July 25, 2018 AGENDA ITEM **#2**3

Executive Director Board Report MoPac Improvement Project (MIP) Austin Memorial Park landscaping coordination

Backup provided: Austin Memorial Cemetery Background Information

MOPAC IMPROVEMENT PROJECT

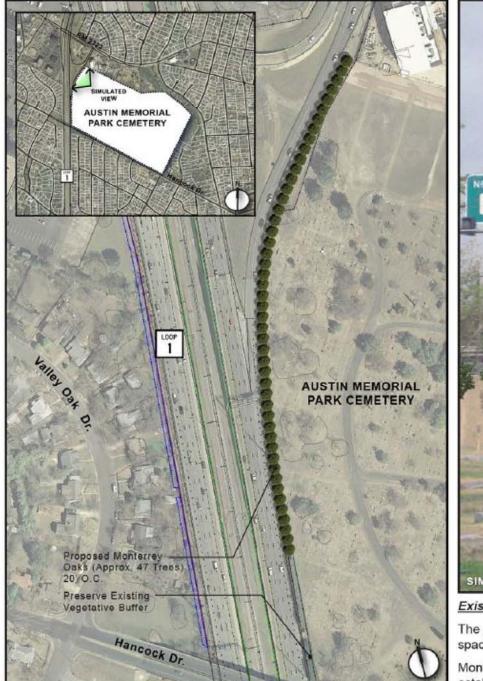
Existing conditions show little screening of MoPac's retaining wall and vehicular travel.

The *simulated tree plantings* represent approximately **ten** years of plant growth after installation. To maximize their screening effect, a spacing of approximately 20 ft. is recommended.

Monterrey Oaks average 30-40 ft. in size depending on growing conditions. They are long lived, fast growing, resistant to oak wilt and once established are quite drought tolerant. They hold their leaves for a long time and are semi-evergreen in Austin's climate.
